REQUEST FOR INFORMATION

- **Contract Number: CNR048**
- **Project: Interstate 24, Bridge Replacement over Spring Street and Oldham Street**
- **Date:**
- **Question:**

PANEL TO BEAM CONNECTION

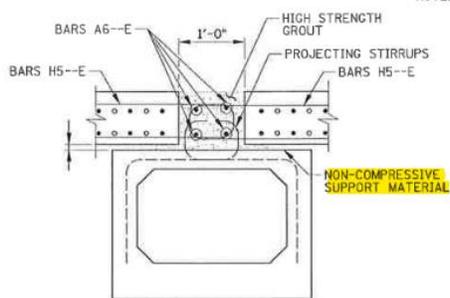
Drawing BR-122-07 Detail Panel to Beam (shown below) calls out a “Non-Compressive Support Material”, what specification or material shall be used here?

The contractor has the option to use a material like bituminous fiberboard or Korolath multi-polymer plastic to support the panels until the closure pour material is in-place and cured. Any material that is used as temporary forming for the closure pours will need to be removed after the closure pour is cured.
